# UNITED STATES PATENT AND TRADEMARK OFFICE

APPLICATION NO.	FILING DATE	FIRST NAMED INVENTOR	ATTORNEY DOCKET NO.	CONFIRMATION NO.
10/618,650	07/15/2003	Hiroshi Kondoh	240266US2	5255
22850	7590	09/21/2005	EXAMINER	
OBLON, SPIVAK, MCCLELLAND, MAIER & NEUSTADT, P.C. 1940 DUKE STREET ALEXANDRIA, VA 22314			TRAN, LONG K	
			ART UNIT	PAPER NUMBER
			2818	
DATE MAILED: 09/21/2005

**Office Action Summary**

## **DETAILED ACTION**

**FIG.3**

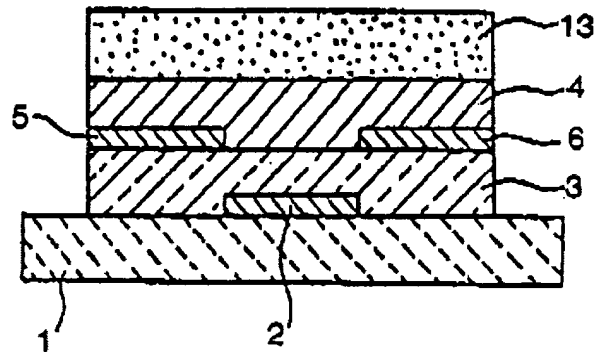
14. Claims **1, 5, 6** and **7** are rejected under 35 U.S.C. 102(b) as being anticipated by Tanaka et al. (US Patent no. 5,892,244).
15. Regarding claim **1**, Tanaka discloses a semiconductor device, comprising: a gate electrode 2 (fig. 3);
- an insulating layer 3 (fig. 3) on the gate electrode; a first electrode 5 (fig. 3) on the insulating layer; a second electrode 6 (fig. 3) on the insulating layer at an interval with the first electrode;

an organic semiconductor layer 4 (fig. 3) disposed in the interval between the first electrode and the second electrode and covering at least part of the first electrode and the second electrode; and

a first resistance layer 13 (fig. 3) made of poly (p-phenylene vinylene) formed on the organic semiconductor layer and having an electrical resistance lower than an electrical resistance of the organic semiconductor layer (column 12, lines 6 – 40; column 15, lines 66 – 67. *Note that Tanaka does not explicitly show the first resistance layer having electrical resistance lower than an electrical resistance of the organic semiconductor layer. However, since the resistance layer and the organic semiconductor layer made of material similar to that of the claimed invention, therefore the first resistance layer inherently having electrical resistance lower than an electrical resistance of the organic semiconductor layer as the instant claimed invention*).

Regarding claim 6, Tanaka discloses the resistance layer is formed to be a plate shape (fig. 3).

Regarding claim 7, Tanaka discloses a substrate 1 (fig. 3) is beneath the gate electrode 2 (fig. 3).

**FIG. 3**

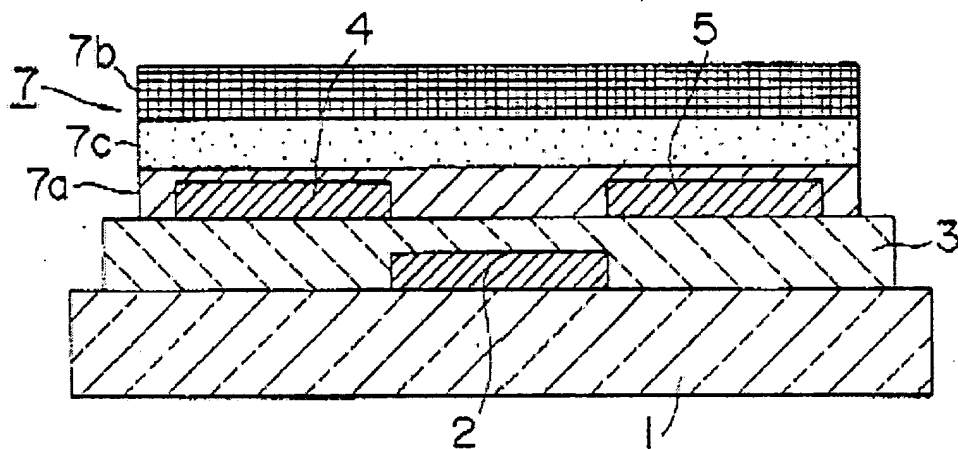
17. Regarding claim 1, Tsumura discloses a semiconductor device, comprising: a gate electrode 2 (fig. 3);

an insulating layer 3 (fig. 3) on the gate electrode; a first electrode 4 (fig. 3) on the insulating layer; a second electrode 5 (fig. 3) on the insulating layer at an interval with the first electrode;

an organic semiconductor layer 7a (fig. 3; col. 6, lines 7 – 9) disposed in the interval between the first electrode and the second electrode and covering at least part of the first electrode and the second electrode; and

a first resistance layer 7b/7c (fig. 3; col. 6, lines 60– 67) formed on the organic semiconductor layer and having an electrical resistance lower than an electrical resistance of the organic semiconductor layer (col. 6, lines 18 – 21), wherein a first

resistance layer is formed of polymers such as polyethylene, polyesters, polyimide, polyphenylenesulfide, poly-para-xylene, and polyacrylonitrile (column 7, lines 1 – 15).

layer having electrical resistance lower than an electrical resistance of the organic semiconductor layer

Regarding claim 6, Tsumura discloses the resistance layer is formed to be a plate shape (figs. 2 & 3).
